CONSERVATION COMMISSION AGENDA

Date: Thursday, February 9, 2023

- 7:00 – 70 Suffolk Rd – NOI continued – construct pool, garage, site features – DEP #239-946**
 - Owner/Applicant. Frank & Kyra van den Bosch
 - Representatives. Andrea Kendall, LEC Environmental; Peter Stephens, Dan K Gordon Assoc; Brian Nelson, MetroWest Engineering

70 Suffolk Rd

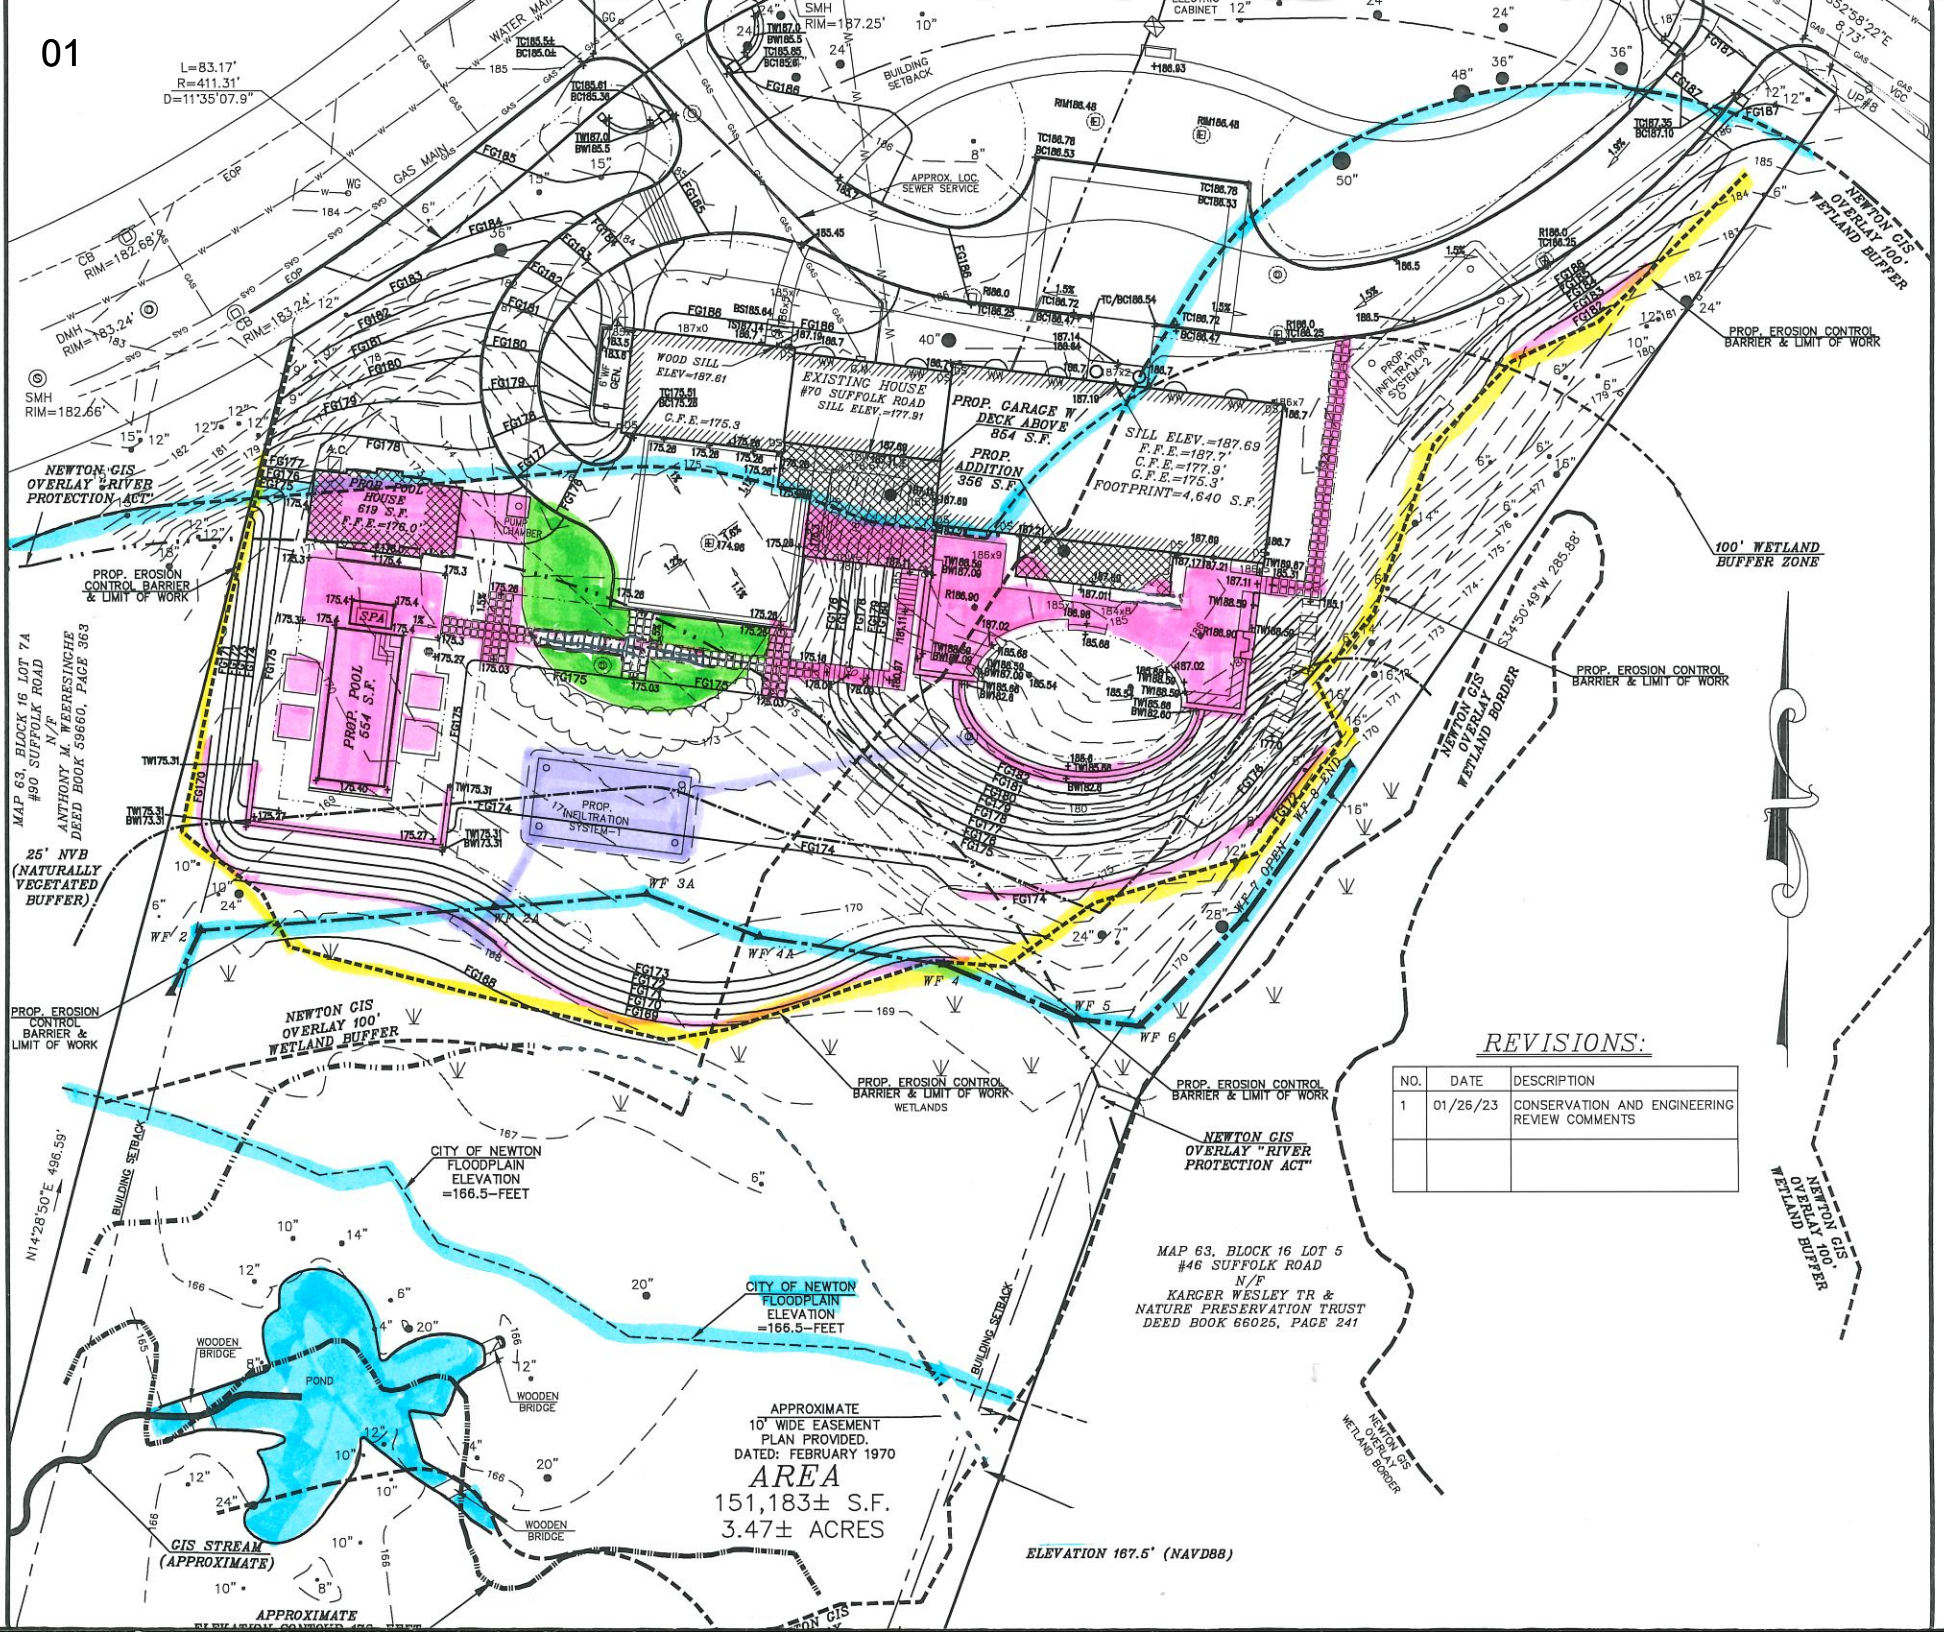
- Staff are concerned that:
 - The erosion control line is shown running through an area to have tree cutting and planting.
 - Runoff from the steep slopes beside the pool may adversely affect slope stability and the adjacent parcel.

- Flow over the level spreader on the eastern side of the property could lead to erosion.
 - Trees are shown being planted over the northern infiltration system.

- Staff note the following possible improvements/additions to the proposal.
 - Proposed trees and shrubs c/should be planted more in the “tongue” of lawn, not just at the very edges.

Drawing Title: MATERIAL AND PLANTING PLAN
Sheet Number: L120

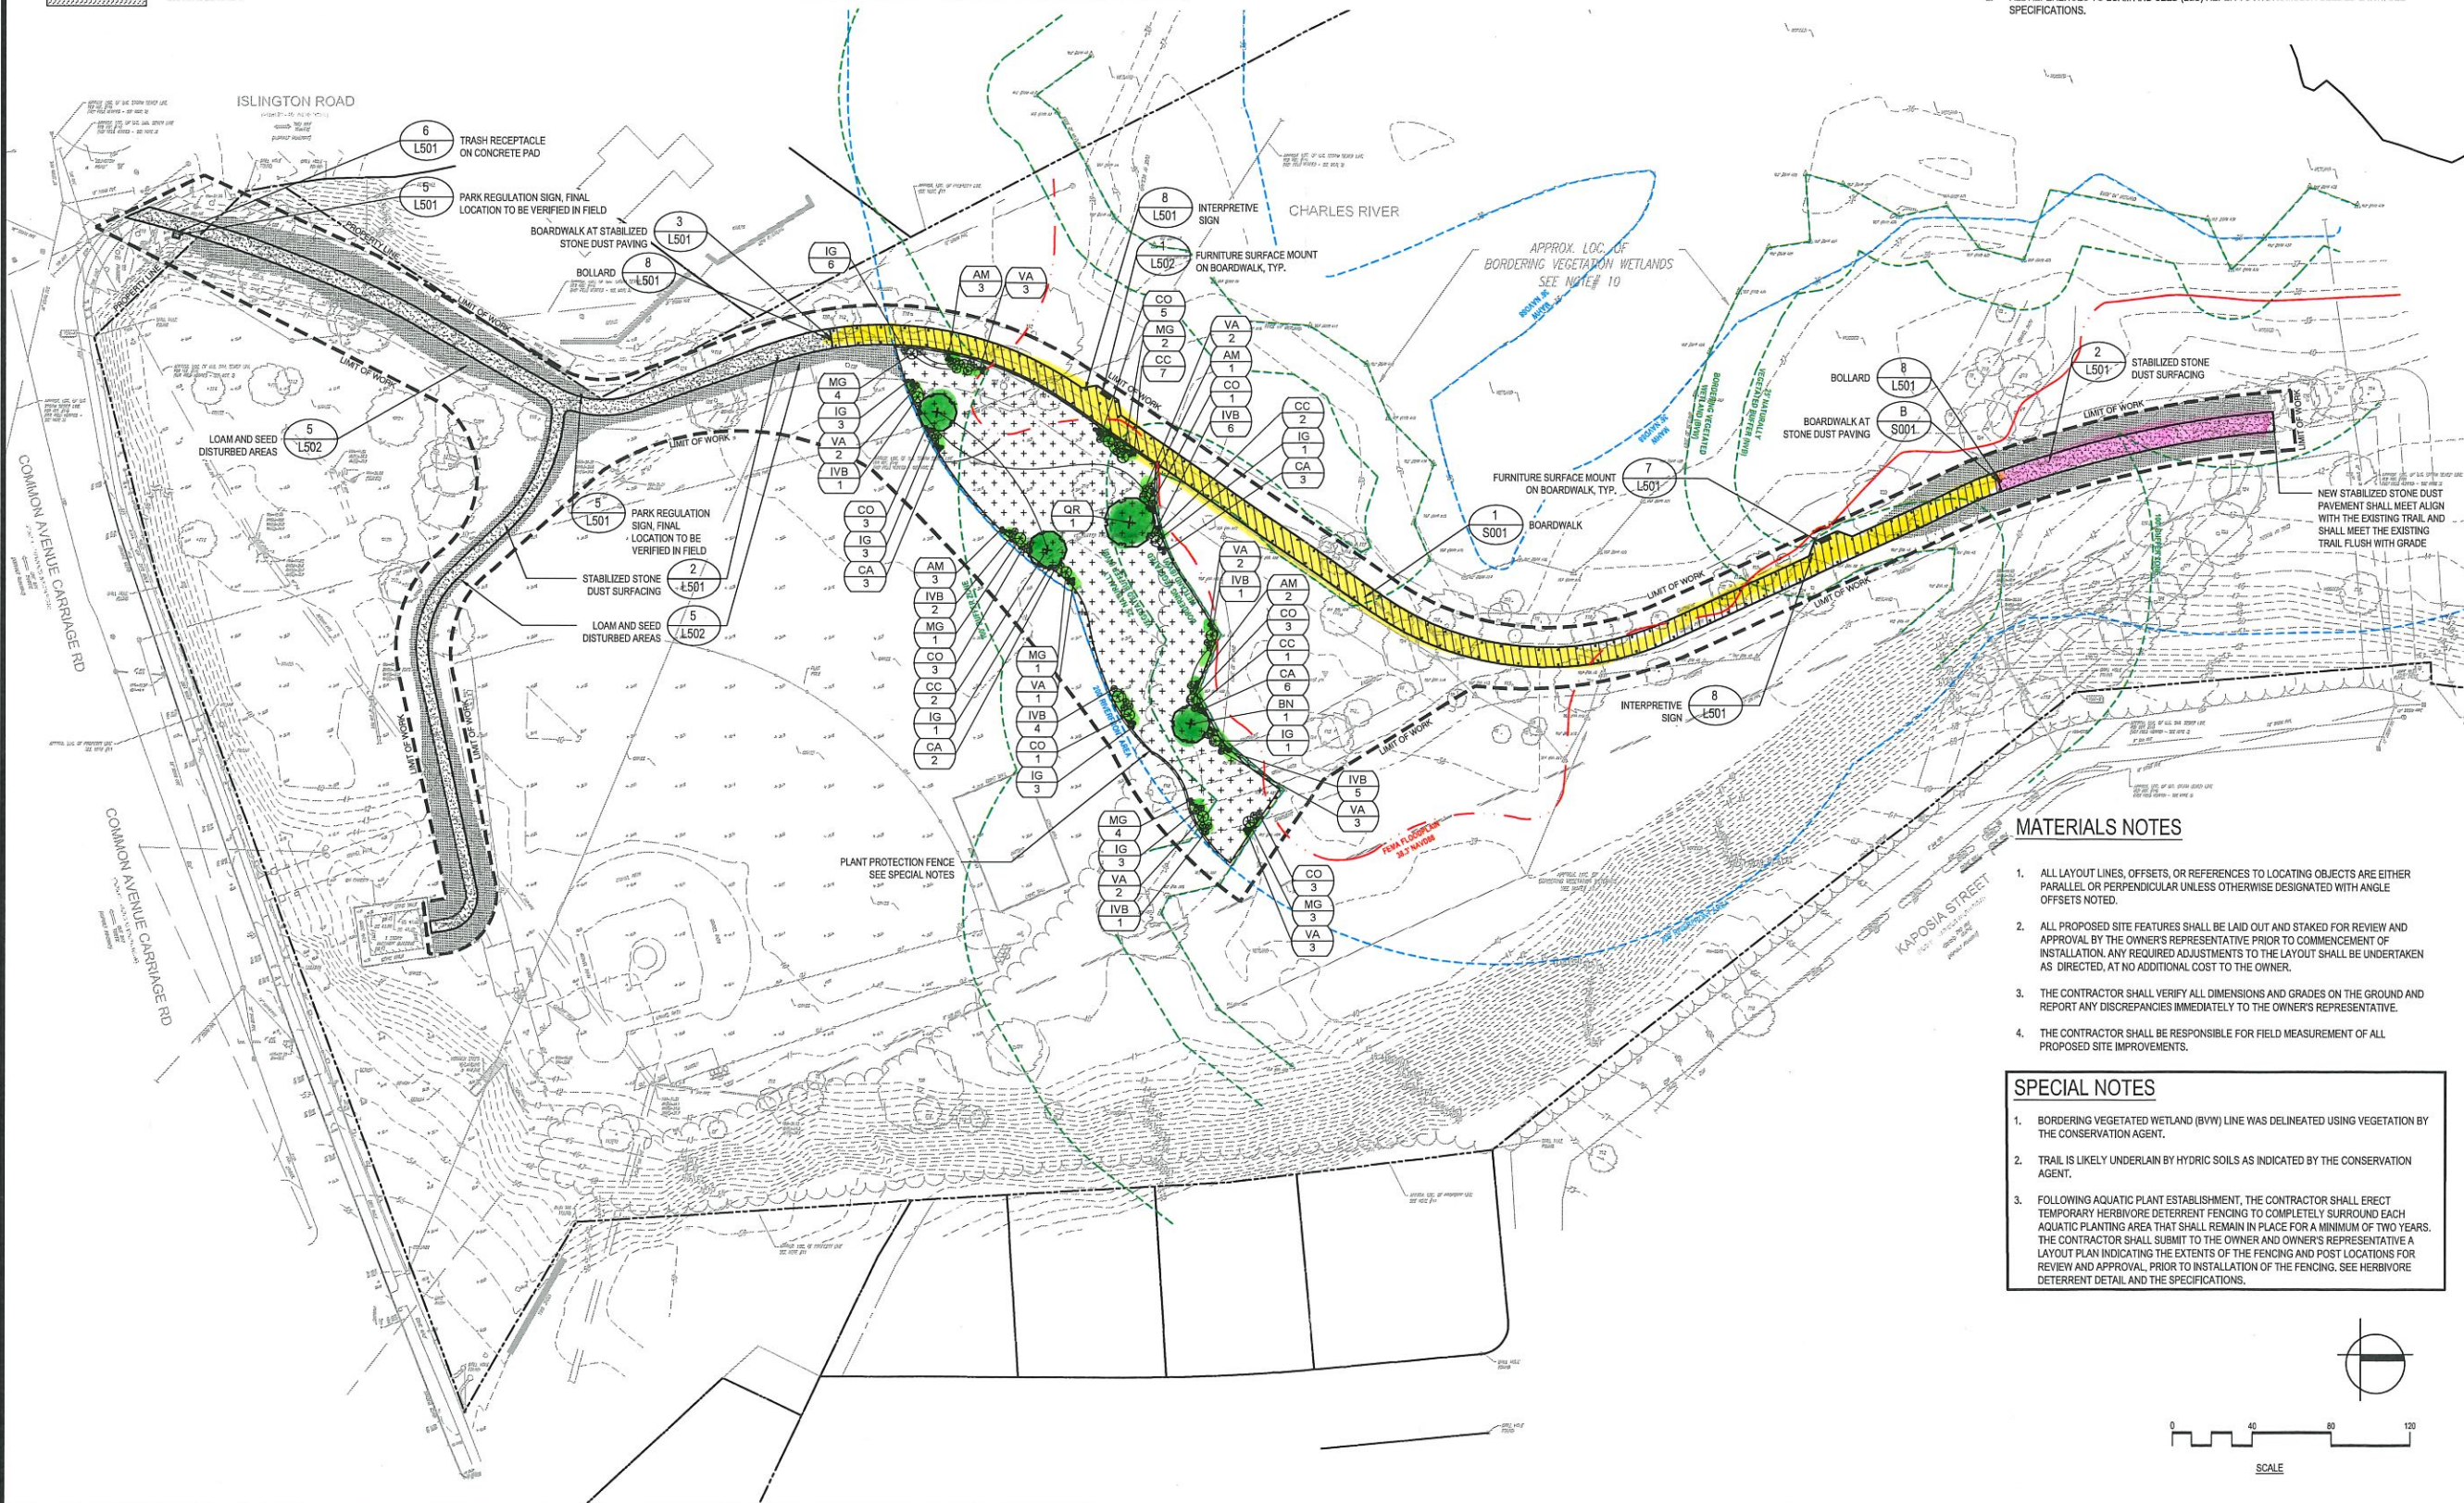
- Staff Questions.
 - Notes mention contractor will delineate BVW prior to work. Why?
 - How will the old gravel path that is outside the new boardwalk be treated? Will material be removed before new loam and seed is applied?

- Notes mention “clearing and grubbing”. Where will that occur?
 - How will trees in the area to be graded and planted be protected?
 - There are two symbols for tree protection. What method(s) is anticipated?

Enforcement Order Resolution Sketch Plan

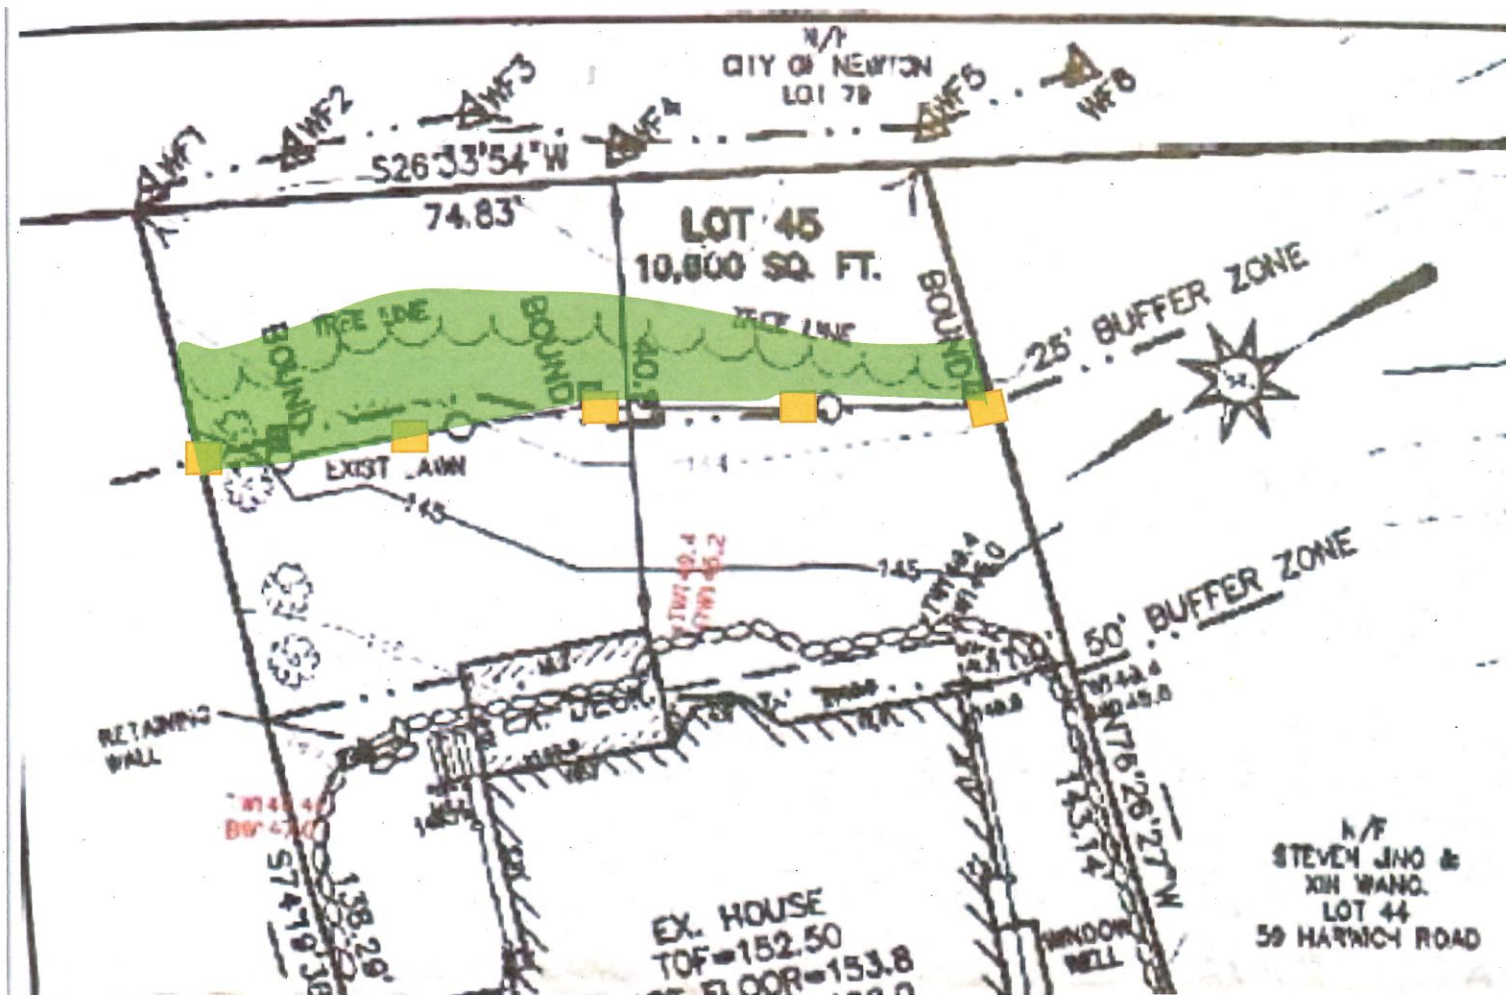
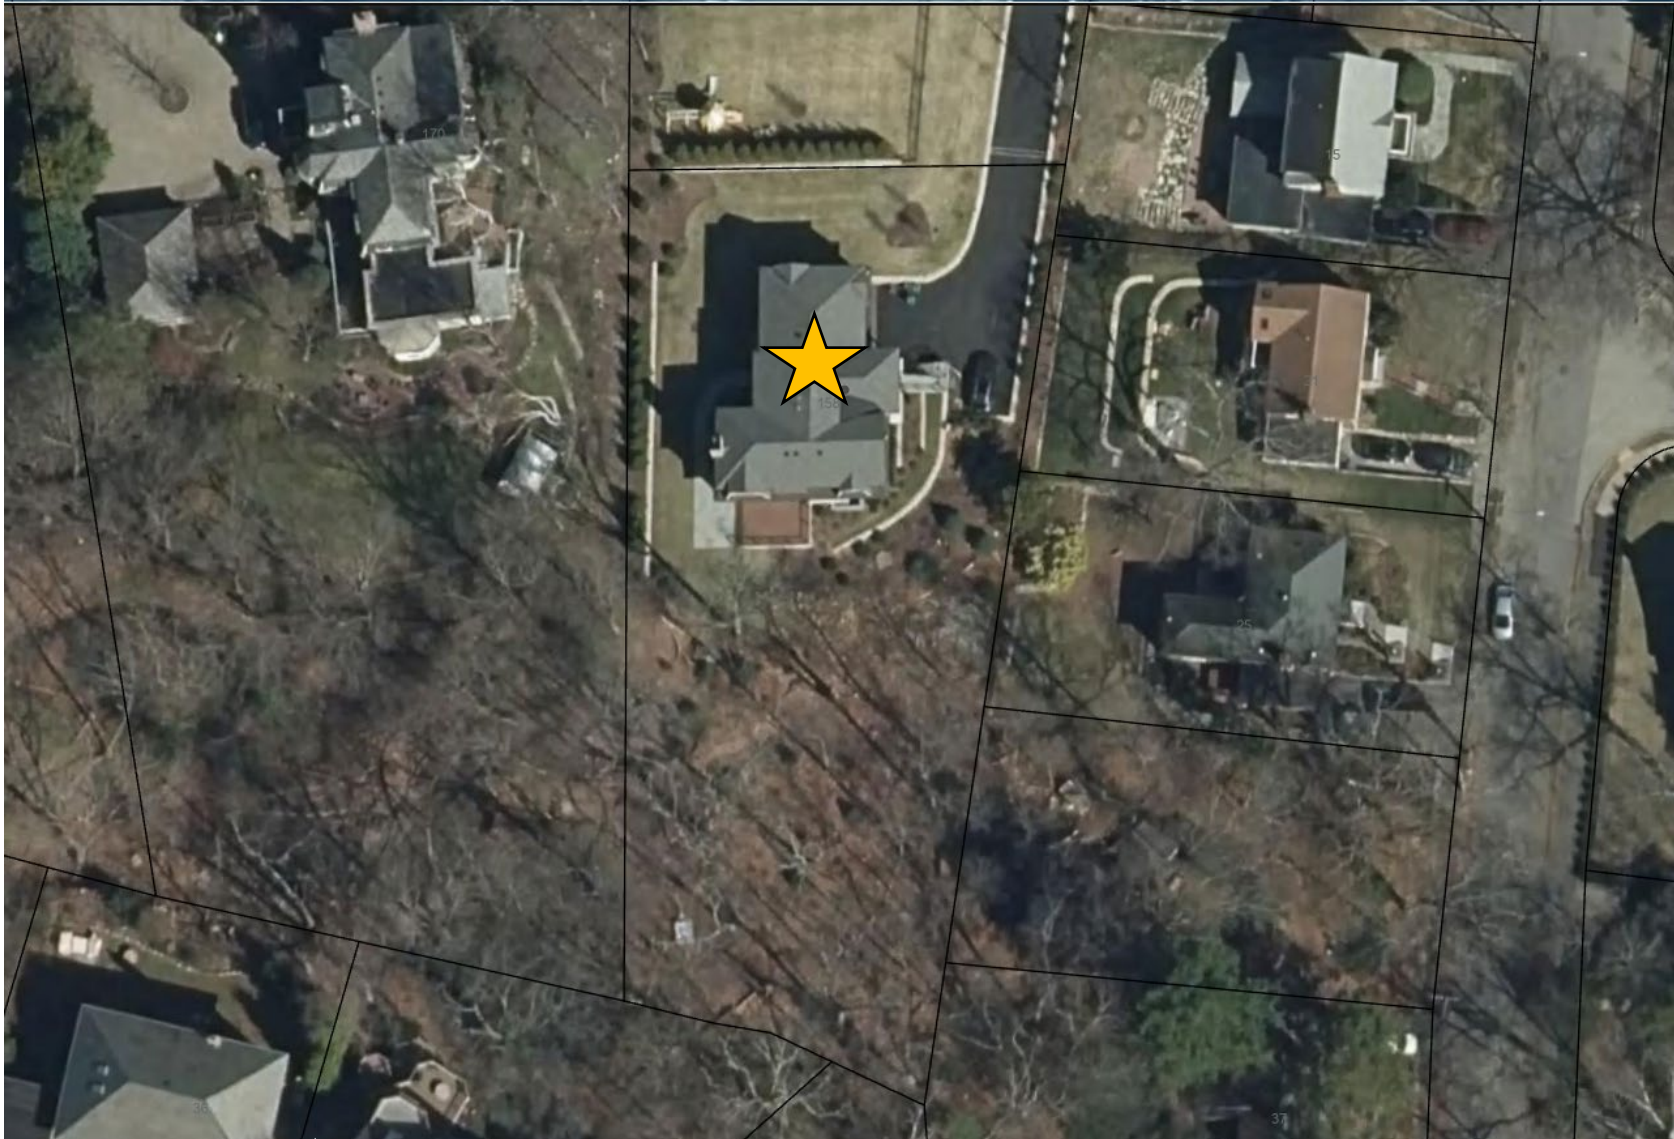
- The owners have been very responsive and the plan submitted seems mostly appropriate.
 - Tree and shrub species list is appropriate.
 - The submitted plan sheet notes both 3 and 4 trees and both 10 and 15 shrubs. The Commission should determine which set of numbers is more appropriate.
